FLIGHT CONTROLS - GARMIN GSM 86 ELEVATOR TRIM MODIFICATION

The current continuous travel capstan design may cause the elevator trim bridle cable to slip.

This service bulletin provides parts and instructions to remove the current elevator servo mount and elevator trim cables and install an improved design.

SB525-27-25
Page 1 of 8

Figure 1. GARMIN GSM 86 ELEVATOR TRIM MODIFICATION (Sheet 1)

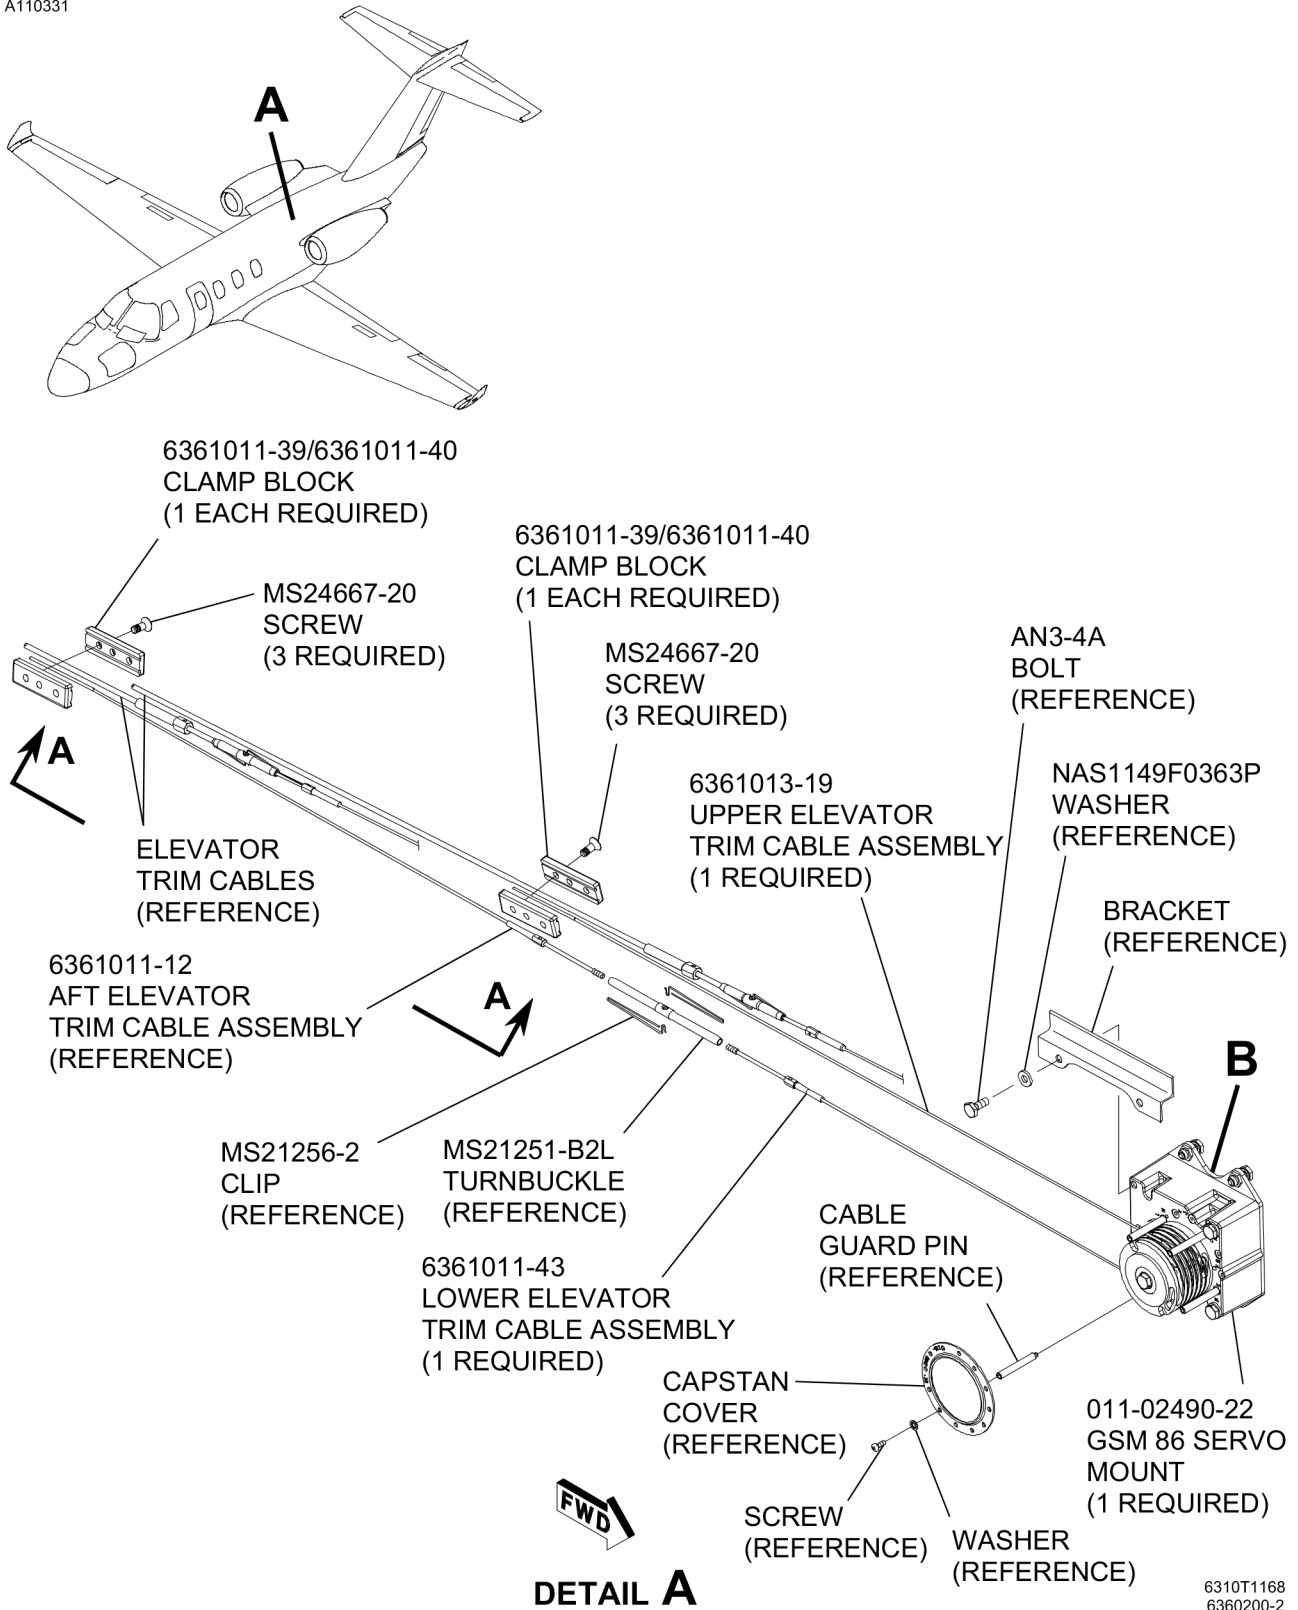
6. (Refer to Figure 1, Sheet 1). Install the 011-02490-22 GSM 86 Servo Mount.
- A. Remove and keep the capstan cover screws, washers, capstan cover and five cable guard pins.

- B. Carefully install the ball ends of the 6361013-19 Upper Elevator Trim Cable Assembly and 6361011-43 Lower Elevator Trim Cable Assembly on the 011-02490-22 GSM 86 Servo Mount.

- (1) Make sure that the ball is fully seated in the capstan drum.
 - C. Install using the kept cable guard pins in its positions on the 011-02490-22 GSM 86 Servo Mount.

- (1) Install using the kept capstan cover screws and washers but do not tighten.
 - (2) Torque the capstan cover screws from 8 to 12 inch-pounds (0.91 to 1.35 Nm). (Refer to the Citation Standard Practices Manual, Chapter 20, Torque Data - Maintenance Practices.)

- E. Put the 011-02490-22 GSM 86 Servo Mount and the cable assemblies in their position at the servo mount bracket assembly.
 - F. Install the 011-02490-22 GSM 86 Servo Mount using the kept four each AN3-4A Bolts and the NAS1149F0363P Washers.

Figure 1. GARMIN GSM 86 ELEVATOR TRIM MODIFICATION (Sheet 2)

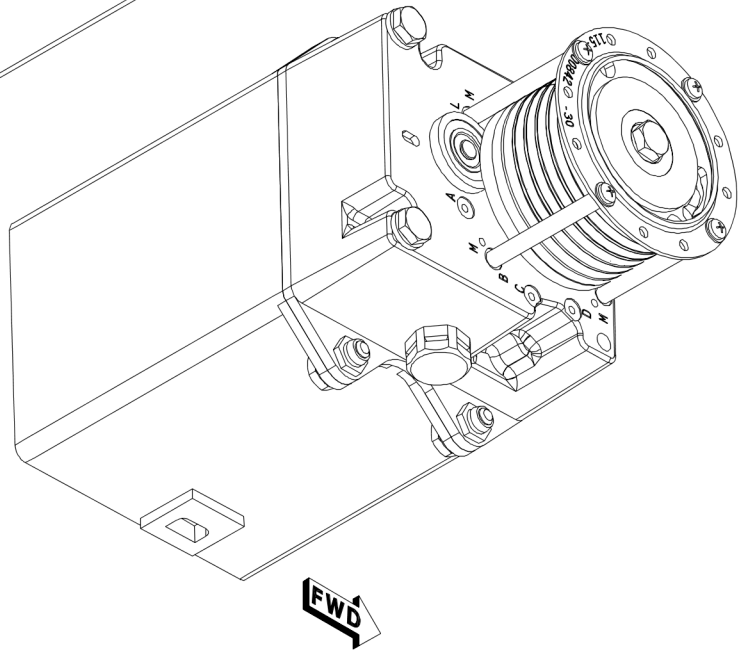
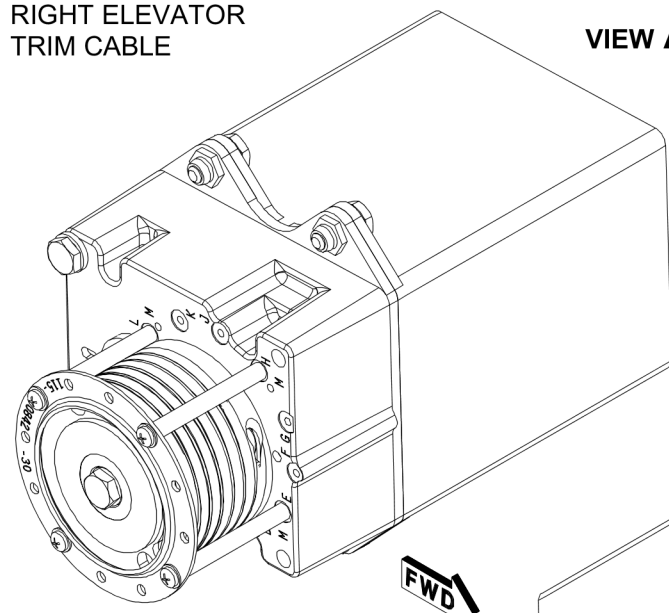
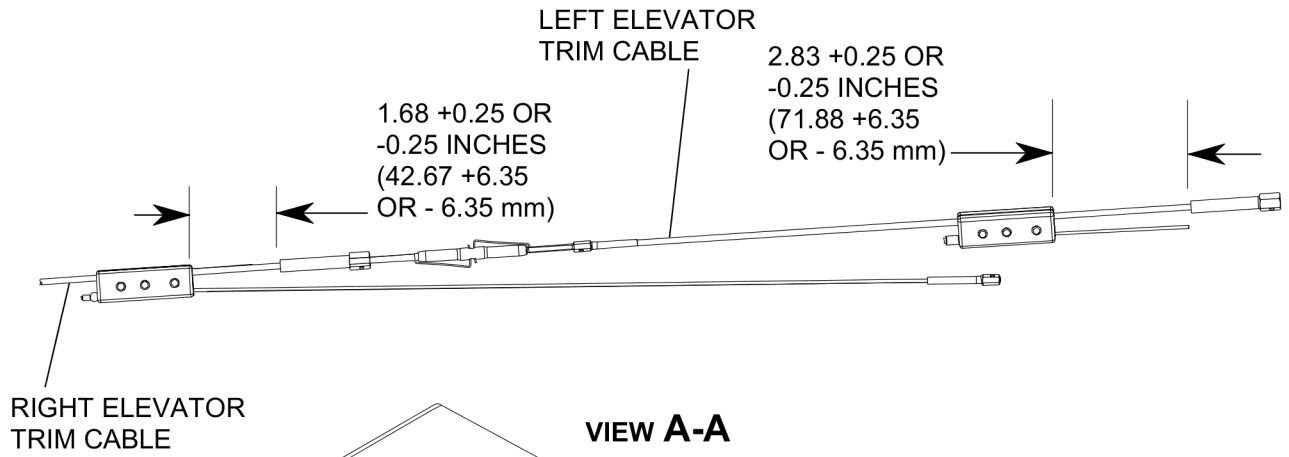
- (1) (Refer to Figure 1, Sheet 2). Make sure that the cable guard pins are located at B,E,H and L.
 - D. Put the kept capstan cover in its position on the cable guard pins.

NOTE: (Refer to Figure 1, Sheet 2.) The forward edge of the forward clamp block is 2.83 ± 0.25 inches (71.88 ± 6.35 mm) from the edge of the left aft elevator trim cable terminal.

NOTE: (Refer to Figure 1, Sheet 2.) The forward edge of the aft clamp block is 1.68 ± 0.25 inches (42.67 ± 6.35 mm) from the edge of the right aft elevator trim cable terminal.

NOTE: THE CABLE GUARD PINS SHOULD BE LOCATED AT B, E, H AND L.
